Columbia
Coronado
Business Class M2
> Cascadia

**Freightliner
Service Bulletin**

Fig. 1, Ambient Temperature Sensor and Harness Installation

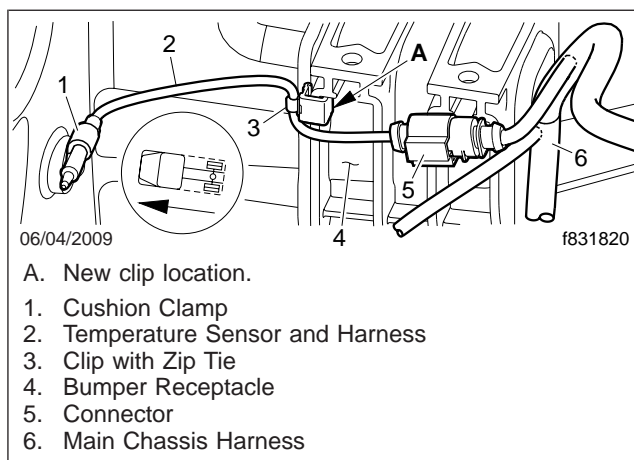
Some Cascadia vehicles built prior to 5/26/09 may have the ambient air temperature sensor harness routed such that it can be chaffed on a radiator baffle. If the harness is rubbed through, the AC may not function. If a failure occurs, install a new sensor and harness per D06-54930-001, detail B. The part and part number have not changed. Only the sensor harness routing has been changed. The new installation can be viewed in EZWiring.

NOTE: In the new location, the clip and zip tie will secure the ambient air temperature sensor harness rather than the main chassis harness.

Refer to **Fig. 1** for the new ambient air temperature sensor harness installation.

7. Using the original clip and a new zip tie, secure the ambient air temperature sensor harness in the new location on the bumper receptacle, as shown in **Fig. 1**.
8. Close the hood.
